Coal Combustion Residue Impoundment
Round 9 - Dam Assessment Report
Big Bend Power Station
Ash Management Units
Tampa Electric Company
Hillsborough County, Florida

Tampa Electric Big Bend Ash Pond Boring Locations

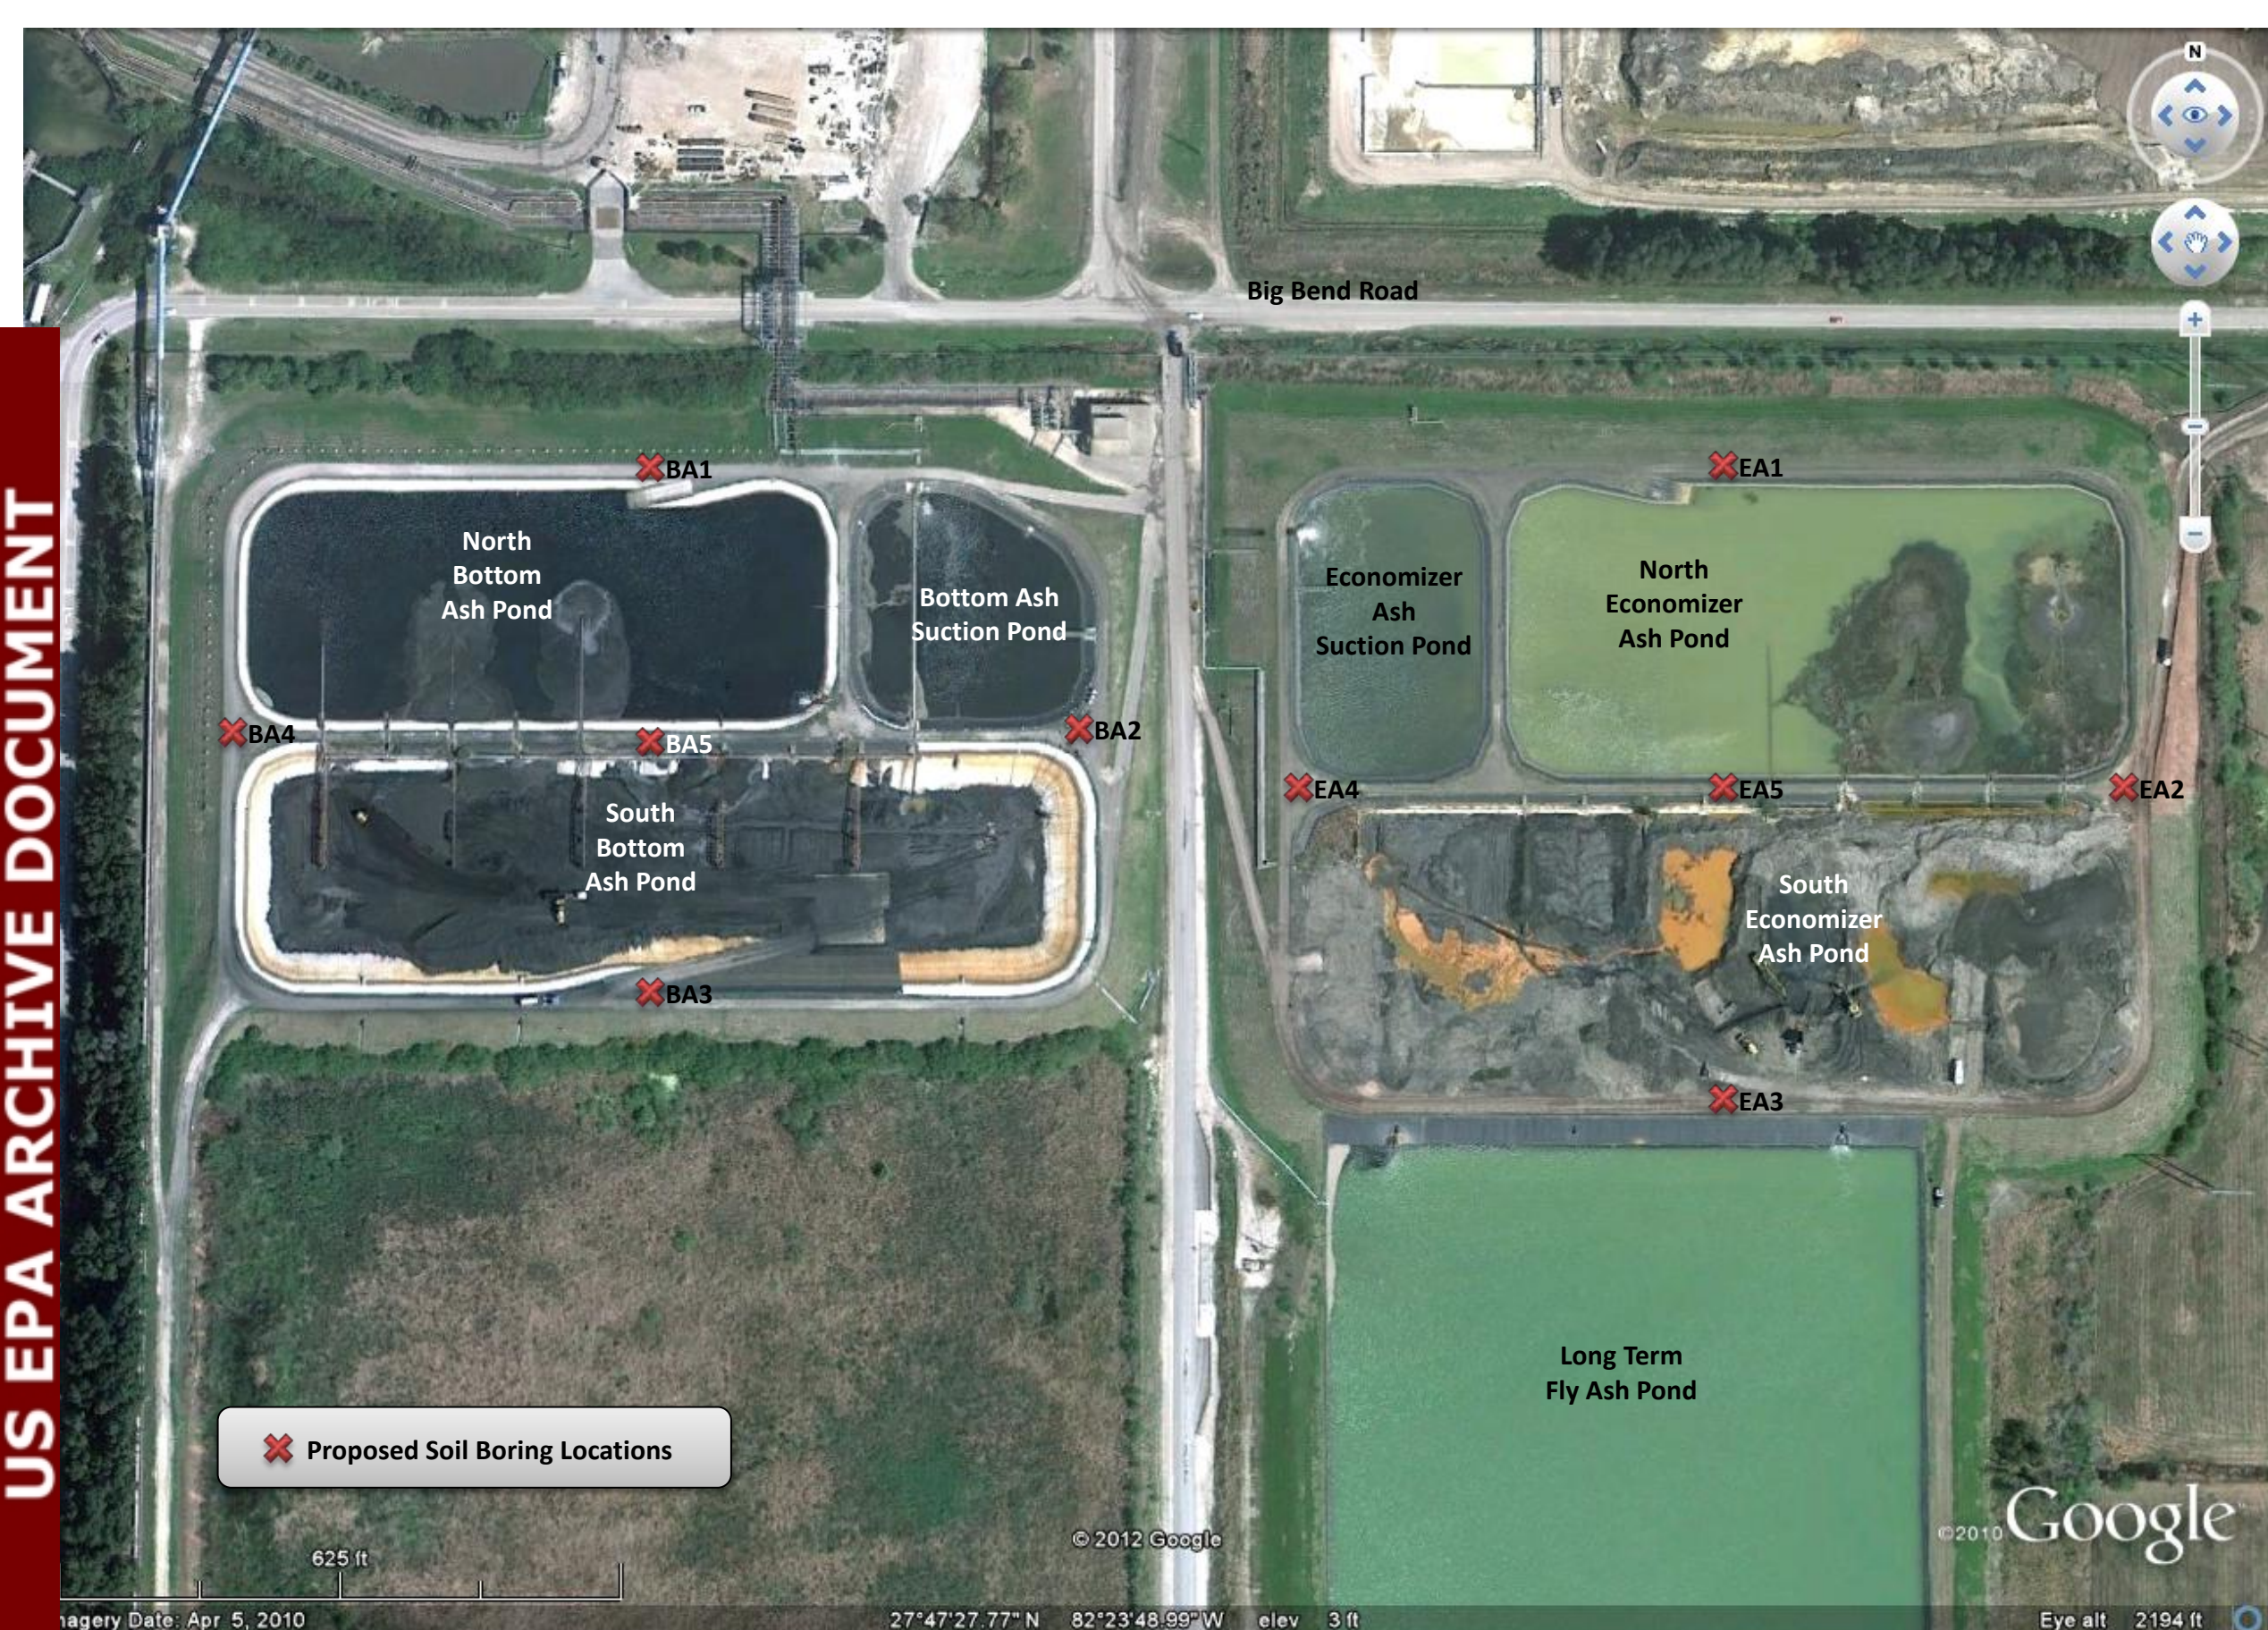
1.2.2 Recommendations Regarding the Hydrologic/Hydraulic Safety ***Hydrologic/Hydraulic analysis should be provided.***

TEC Response: TEC has hired a geotechnical engineering firm to perform systematic soil borings of the dikes for the four impoundments in question. Figure 1 illustrates the locations at which core data will be obtained and analyzed to verify that the original design assumptions and stability analyses for the dikes remain valid and to obtain phreatic surface data sufficient to perform hydraulic analyses. This work will be initiated in March 2012.
